SUBJECT: VIRGIL C. SUMMER NUCLEAR STATION, UNIT 1 - STAFF ASSESSMENT OF
RESPONSE TO 10 CFR 50.54(f) INFORMATION REQUEST – FLOOD-
CAUSING MECHANISM REEVALUATION (TAC NO. MF1112)

Enclosure:
Staff Assessment of Flood Hazard
Reevaluation Report

VIRGIL C. SUMMER NUCLEAR STATION, UNIT 1

DOCKET NO. 50-395

Figure 3.3-2. Service Water Pond and Monticello Reservoir

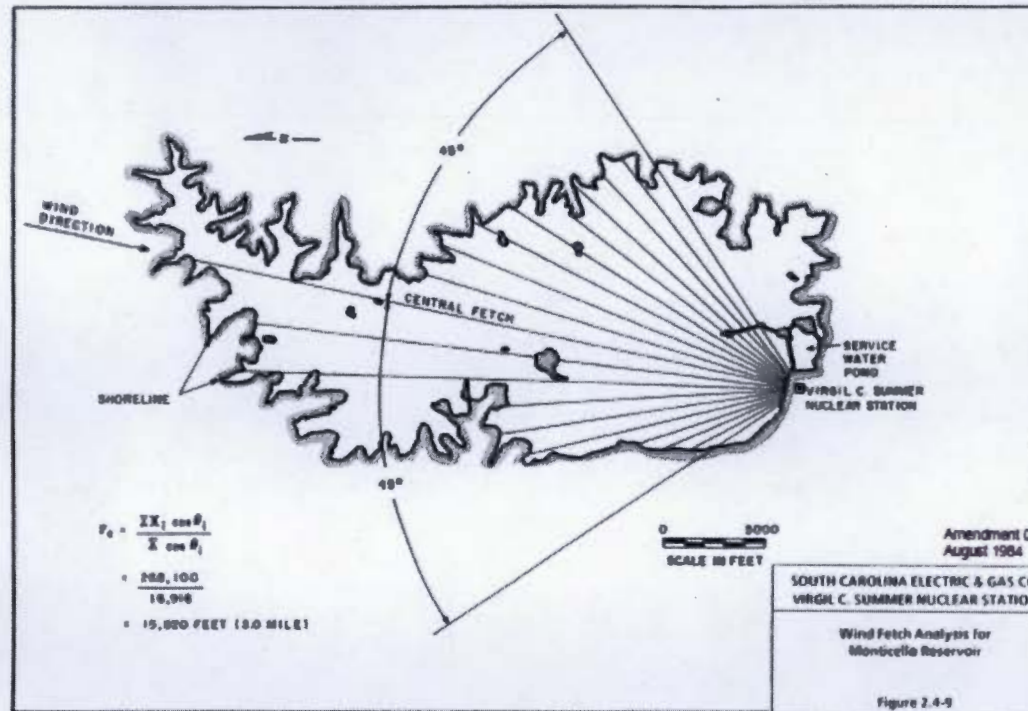
The staff reviewed the licensee's description of its Monticello Reservoir drainage area PMF calculation in the FHRR (SCE&G, 2013a). Given the significant role that the Monticello Reservoir plays in the licensee's analysis of the PMF from rivers and streams, and the need to review the formulation of the model's complex spatially, and temporally distributed input, the staff requested that the licensee provide a detailed description of the analysis it completed to support its conclusions. The licensee provided a detailed description of the PMF estimation in the Monticello Reservoir drainage area (SCE&G, 2014b, RAI 3 response). The licensee described the process by which the 72-h PMP depth of 47.7 in (121 cm) was determined to result in an estimated maximum water-surface elevation in Monticello Reservoir at the North Berm of 437.0 ft (133.2 m) when wave action is considered (SCE&G, 2013a).⁸ All of these water surface elevations are below the 438.0 ft (133.5 m) crest elevation of the North Berm (See Figure 3.3-2).

In the VCSNS, Unit 1 FHRR (SCE&G, 2013a), the SWP is described as a Seismic Category 1 impoundment that serves as the Ultimate Heat Sink for VCSNS, Unit 1. The SWP is adjacent to Monticello Reservoir (Figure 3.3-2). The SWP is separated from Monticello Reservoir by two islands and three Seismic Category 1 dams, which have crest elevations of 438.0 ft (133.5 m) on three sides. The crest elevation of the West Embankment is 435.0 ft (132.6 m). The West Embankment adjoins the VCSNS, Unit 1 plant yard grade, and therefore represents the land elevation value critical for assessment of the PMF maximum water-surface elevation in the SWP.
